REFERENCE LHC-TC-EC-00XX

Date: 2017-12-20

ENGINEERING CHANGE REQUEST

Installation of new passive absorbers (TCAPM) for warm magnet protection in IR7

Figure 1 — Illustrative view of the present and post-LS2 layouts of the IR7 Q5 [2,3].

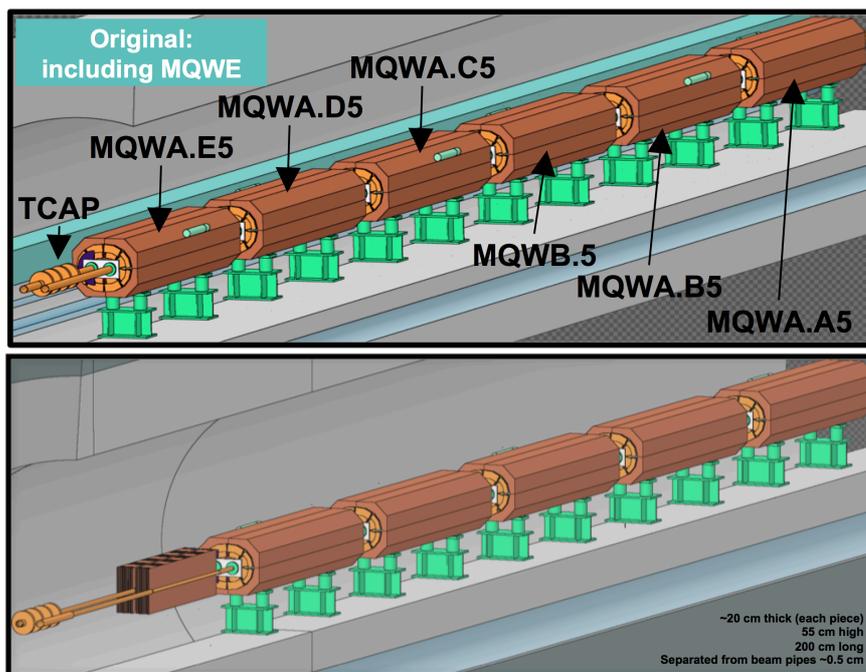
Details of mitigation plans for the absorbed dose of warm quadrupoles and dipoles in the betatron cleaning insertion (IR7) of the LHC can be found in [1]. Mitigations include the removal of the first (along the incoming beam direction) MQW module of the Q5 assemblies at either side of IP7. This leaves the subsequent magnets more exposed to radiation doses. In order to make the intervention effective for the overall dose reduction, an upgrade of the passive collimation system is required. As a design goal for this upgrade, we set the requirement that all remaining 5 magnets should receive doses not exceeding the levels that they receive in the present layout. This requires adding one new passive absorber per beam, which we call TCAPM (Target Collimator Absorber Passive Mask), at the locations of the magnets that will be removed.

The requirements and a detailed performance assessment of [possible](#) new layouts were discussed in various Collimation Upgrade Specification meetings – see presentations by C. Bahamonde in [2,3,4,5,6]. Figure 1 shows in an illustrative sketch, taken from the FLUKA geometry used in simulations, [of](#) the present layout and the modified one [2,3].

Figure 3 — Overall design of the TCAPM. Lengths are given in mm. Courtesy of L. Gentini [8].

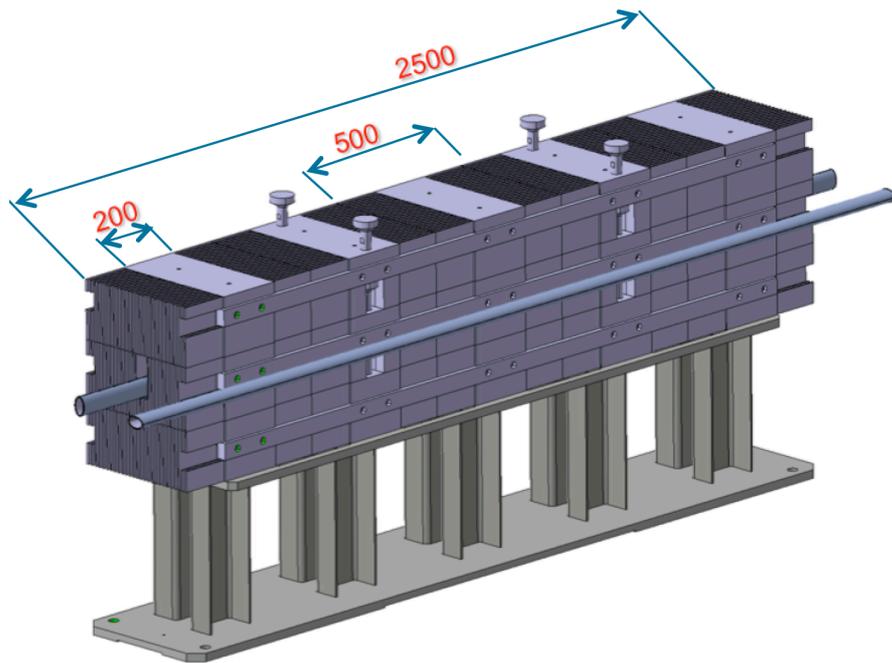
The new absorber's present design [8] is shown in Fig. 3. A new support that will be installed under the vacuum chamber will house a modular structure made of steel blocks, assembled together to fill a volume that ensures adequate shielding of the downstream magnet. The absorbing part consists of three block assemblies shown in Fig. 4. The assemblies 1, 2 and 3 weigh respectively 835 Kg, 795 Kg and 820 Kg, for a total of about 2800 kg with the support. The TCAPM transverse cross section is shown in Fig. 5. The absorber assemblies are mounted around the elliptical beam pipes in a way that leaves minimum empty spaces. More detailed technical drawings are under preparation. A preliminary integration layout is shown in Fig. 6.
